**PLANNING COMMISSION
THURSDAY, AUGUST 11, 2022 6:00 PM**

RE: COPC: Carlyle Drive and East Main Street

**COPC Reynoldsburg
Medical Office Building**
8077 East Main St.
Reynoldsburg, Ohio 43068
FOR
Central Ohio Primary Care

CITY OF REYNOLDSBURG, FRANKLIN COUNTY, OHIO
FINAL DEVELOPMENT PLAN
FOR
COPC REYNOLDSBERG
E MAIN ST
TITLE SHEET

LANDSCAPE PLAN

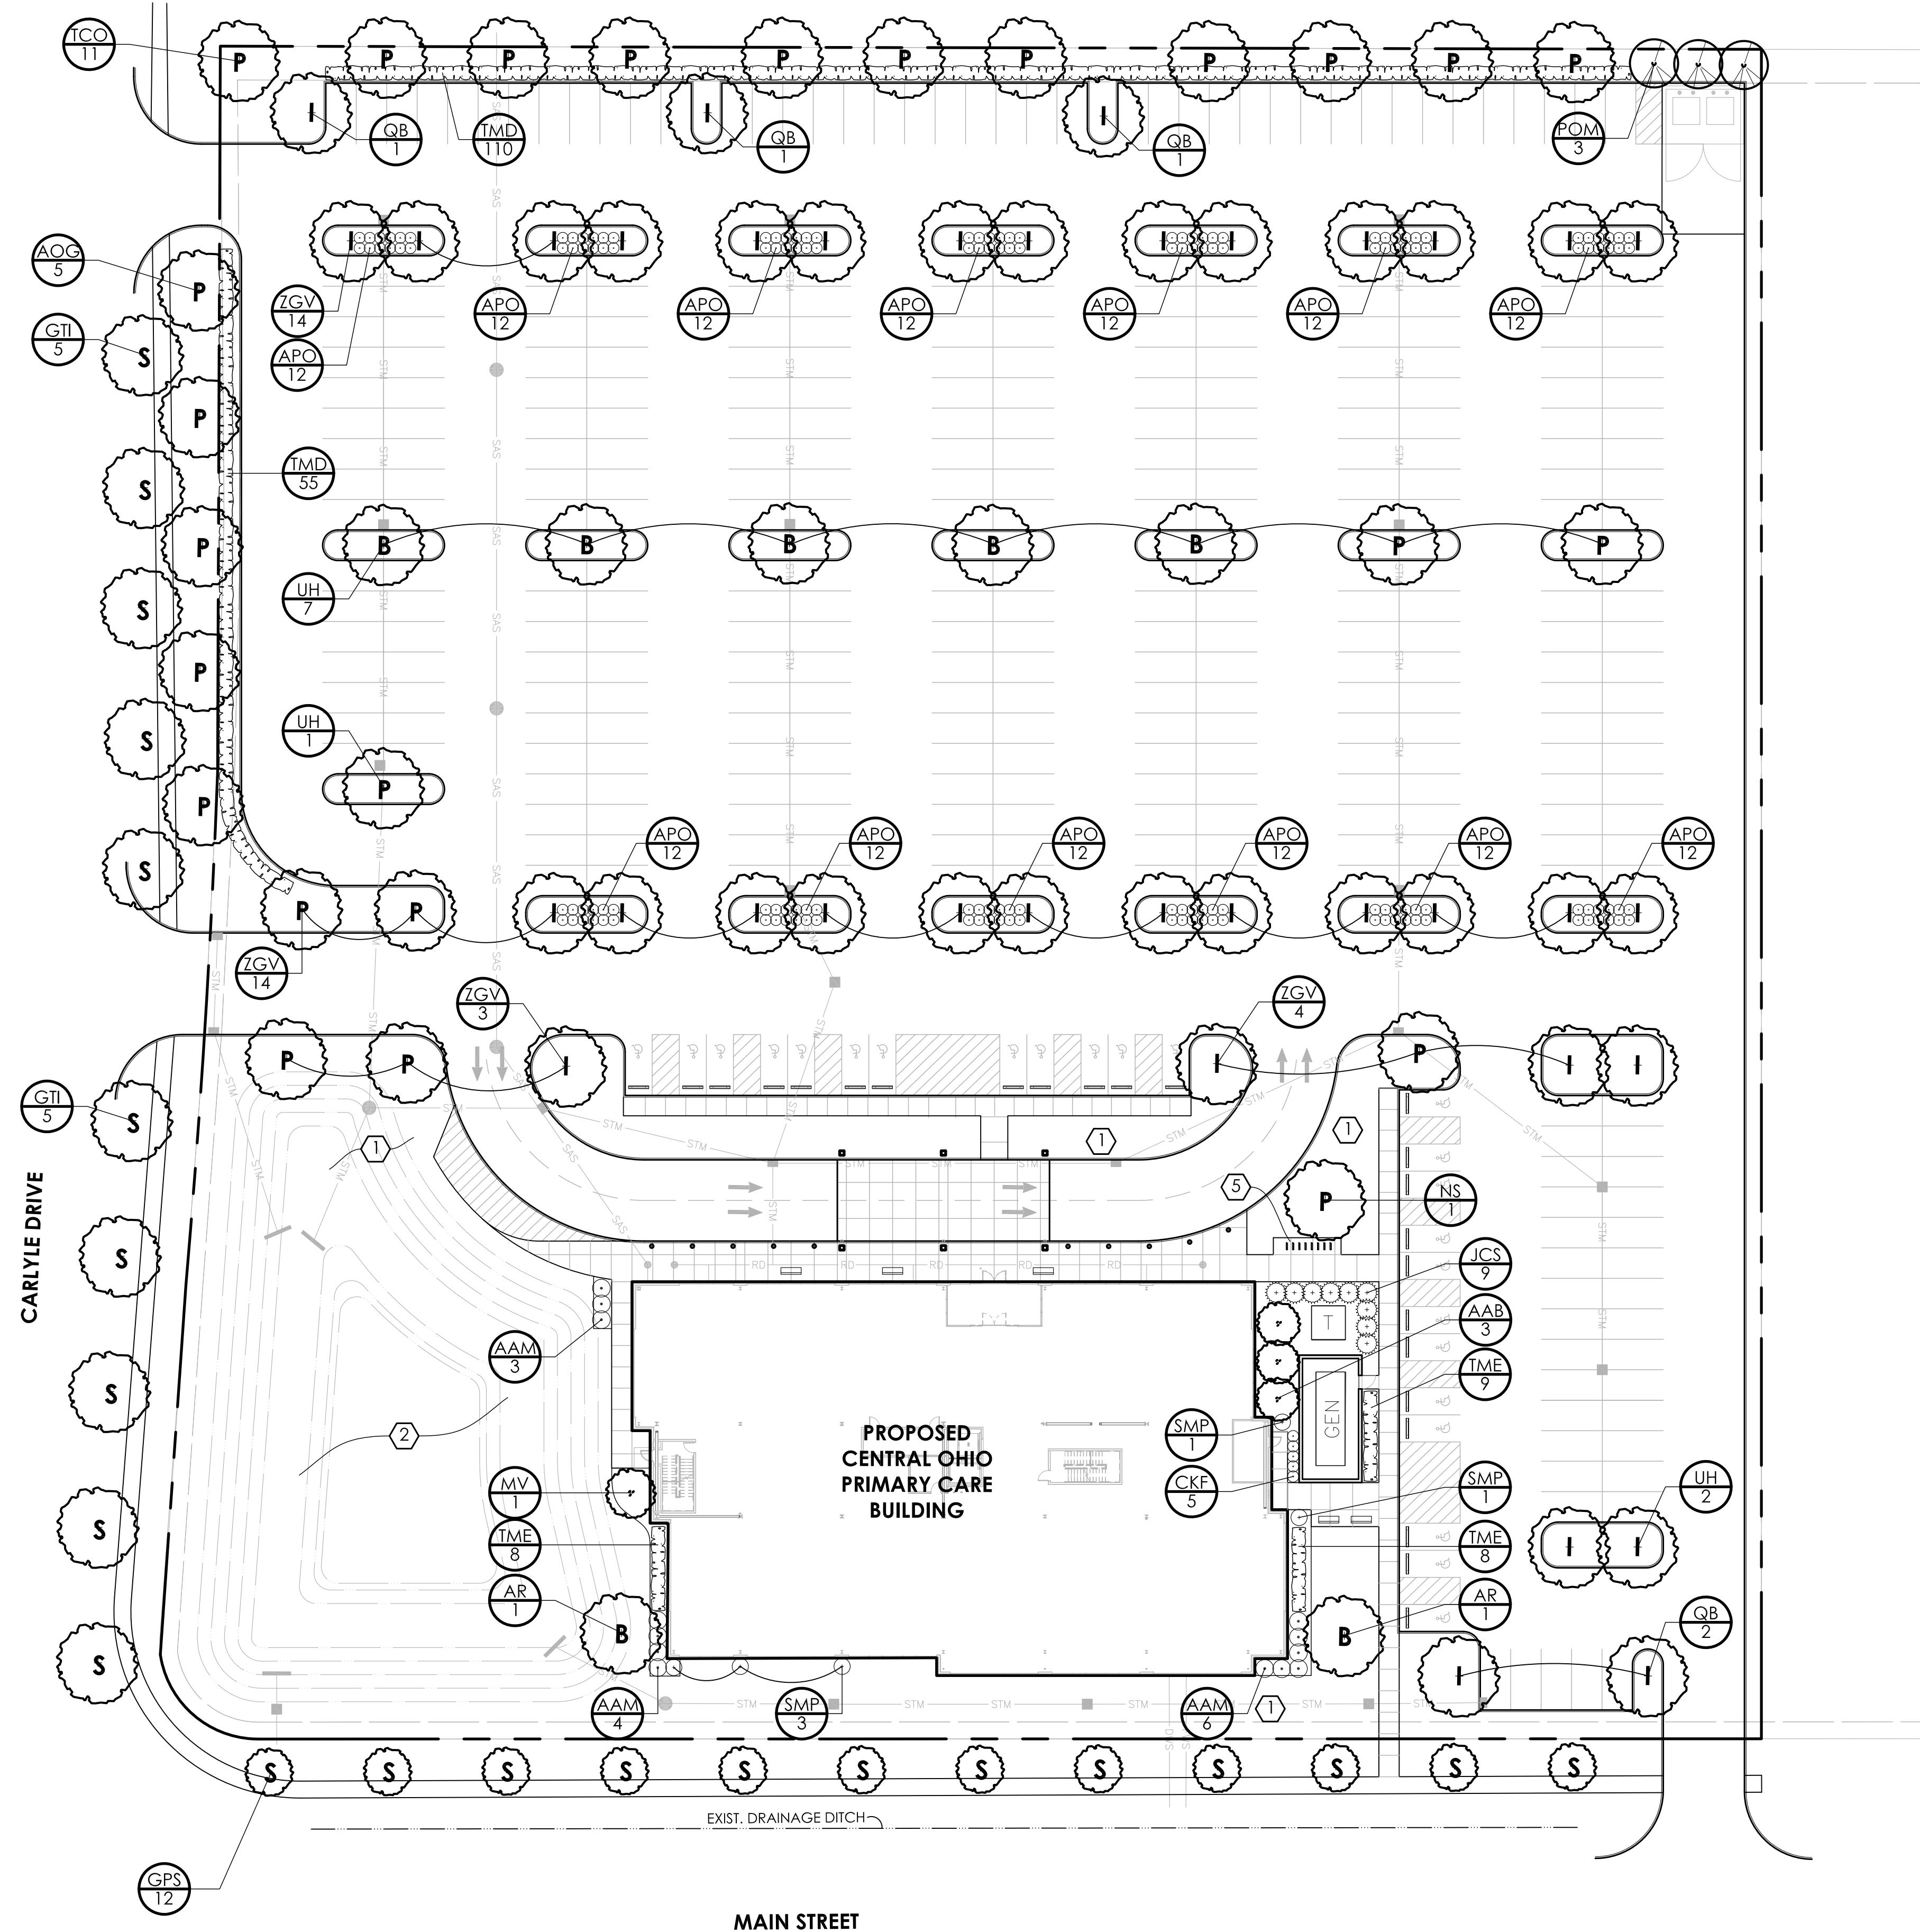
- a. Along the north edge, plan is required to provide a 6 ft. tall screen hedge. The plan's requirements data table indicates this will be achieved with 6 ft. tall Sea Green Juniper. However, the plan is showing Dense Yew, which will not achieve the required screen height. Revise scheduled plants to a species that will achieve the required height.
- b. Interior lot landscaping requires 15 inches of total tree planting, not 13 inches as indicated. The provided trees are indicated as 14 inches provided. However, the plan indicates 7 trees scheduled at

2.5” cal., equaling 17.5 inches, meeting the requirement. No plan revision is needed, but we recommend updating the requirement table to document the correct figures.

Statistics						
Description	Symbol	Avg	Max	Min	MaxMin	AvgMin
Calc Zone #1	+	1.0 ft	18.1 ft	0.0 ft	N/A	N/A
Calc Zone #1	X	1.7 ft	18.1 ft	0.3 ft	60.3 ft	6.7 ft

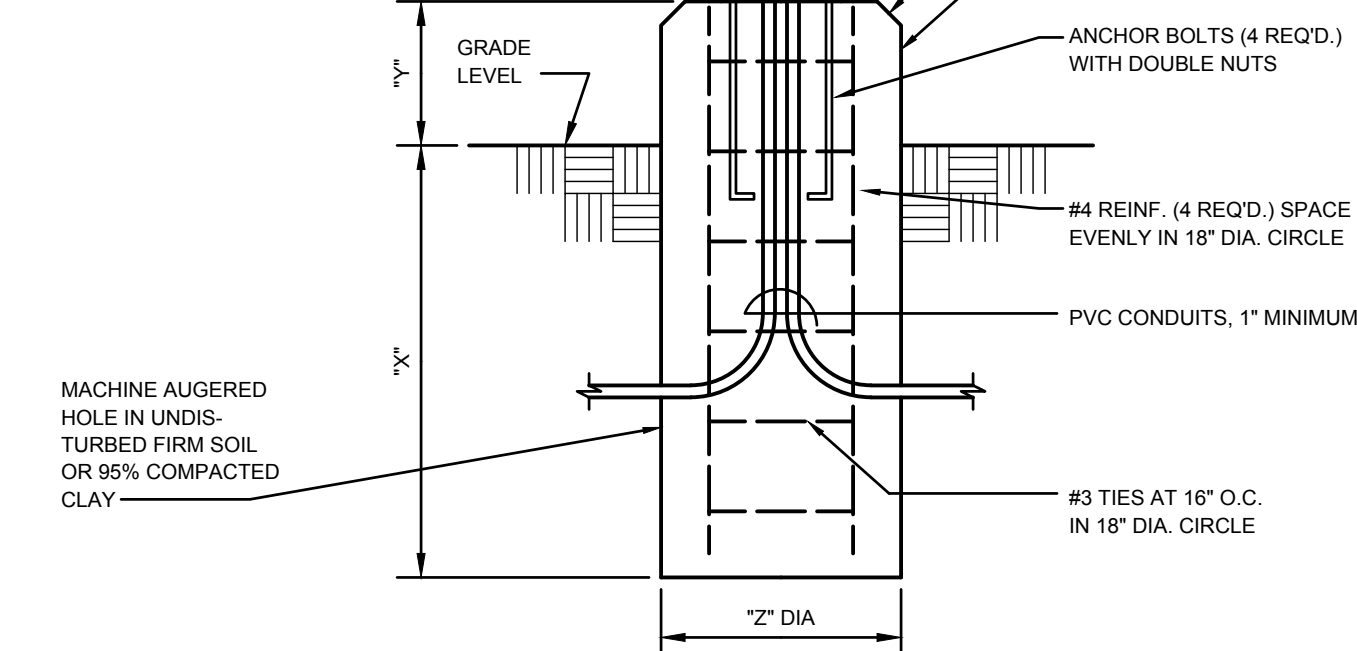
- a. The average horizontal illumination level on the ground along a property line adjacent to a residentially zoned property shall not exceed an average intensity of 0.5 foot-candles. Sheet E002 “Statistics” data table “Calc Zone #1” indicates an average of 1.0 FC, exceeding the maximum permitted. It appears that this calculation may also include several unlit areas of the site away from the residential property line, based on the point symbol. The fixtures nearest the residential properties should be adjusted to include shielding to minimize light trespass.
